Log # TXX-91198  
File # 915  
10010

May 20, 1991

SUBJECT: COMANCHE PEAK STEAM ELECTRIC STATION (CPSES)  
DOCKET NOS. 50-445 AND 50-446  
RESPONSE TO REQUEST FOR ADDITIONAL INFORMATION  
REGARDING TOPICAL REPORT RXE-89-003,  
"STEADY STATE REACTOR PHYSICS METHODOLOGY"

ADDITIONAL INFORMATION REGARDING  
TOPICAL REPORT RXE-89-003,  
"STEADY STATE REACTOR PHYSICS METHODOLOGY"

FIGURE 3. COMANCHE PEAK STEAM ELECTRIC STATION UNIT 1,  
CYCLE 1, BORON LETDOWN

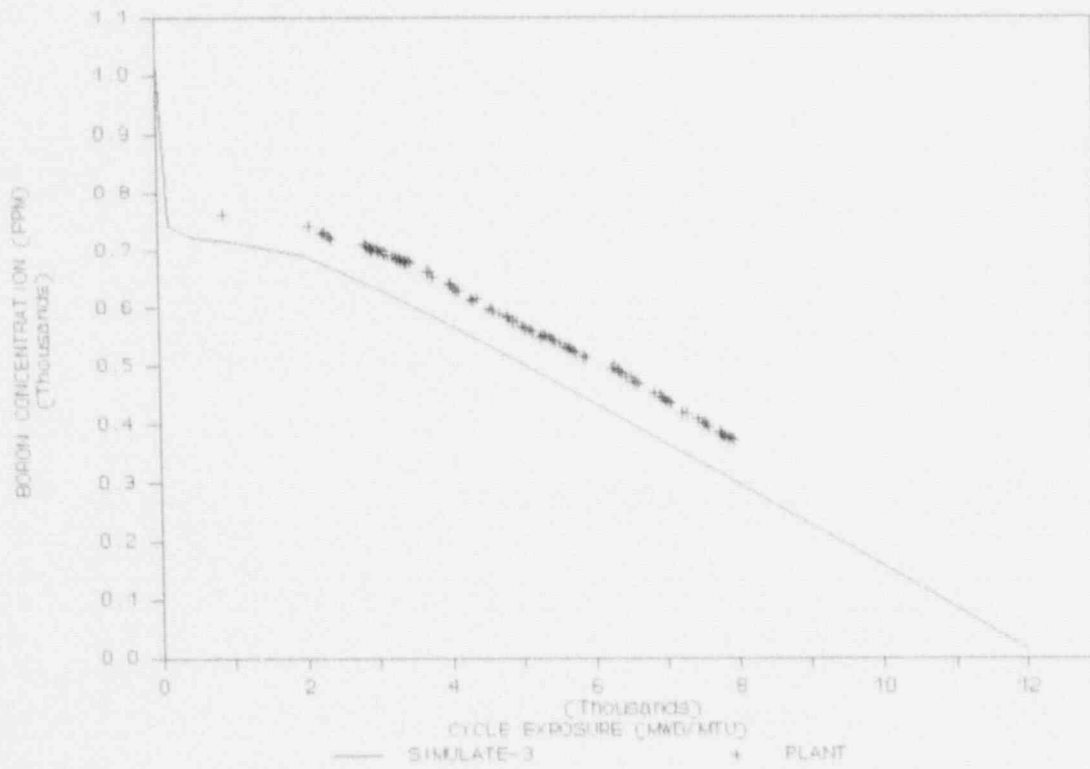
Both PDQ-7 and SIMULATE-3 analyses of the Catawba-1 boron letdown curves show an underprediction of the boron concentration throughout most of Cycle 1. SIMULATE-3 also underpredicts the letdown curves for Prairie Island Cycles 5-10. Is this underprediction expected in the Comanche Peak-1 calculations? What is the measured vs. calculation experience thus far in Cycle 1?

The differences between the calculated and measured boron letdown curves were extensively reviewed for both Catawba Unit 1 and Prairie Island Unit 1. The following observations have been made:

- a. The cycle exposure corresponding to a Hot Full Power critical boron concentration of 10 ppm can be consistently predicted with SIMULATE-3.

- b. Fuel cycles which contain mostly fresh fuel at the start of the cycle, typically Cycle 1, will show an underprediction of boron during most of the cycle when using CASMO-3/SIMULATE-3 or CASMO-3/PDQ-7.
- c. The underprediction in boron concentration is much less pronounced in reload cycles.
- d. The apparent underprediction in Prairie Island is amplified by the burnout of B-10 in the soluble boron. This phenomenon has been confirmed for several PWRs including subsequent cycles in Prairie Island. The magnitude of the effect is projected to be between 20 ppm and 40 ppm.

Based on the above, an underprediction was expected for CPSES Unit 1, Cycle 1. The calculated and measured boron letdown curve for CPSES Unit 1, Cycle 1 is presented in Figure 3.
